XR100 Series March 2012

Hardware Update

Updated Hardware

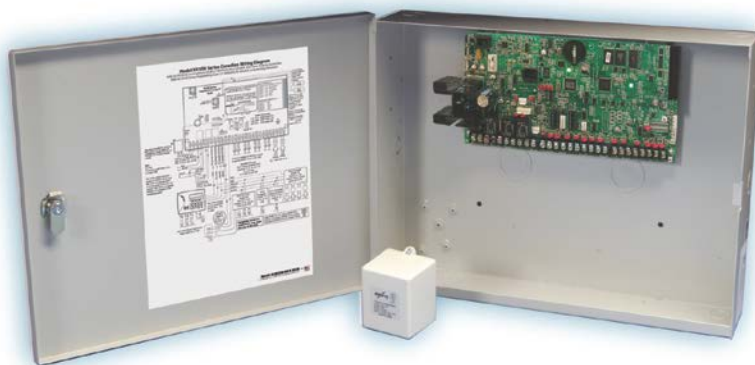
Beginning March 2012, all XR100 Series panels are being manufactured with updated Level P hardware.

The XR100 Series panels with updated Level P hardware now allow the 463G Digital Cellular Communicator to be installed in the Interface Card Connector (J6). In addition, the LX-Bus connection on the 463G can be used for zones 500-599.
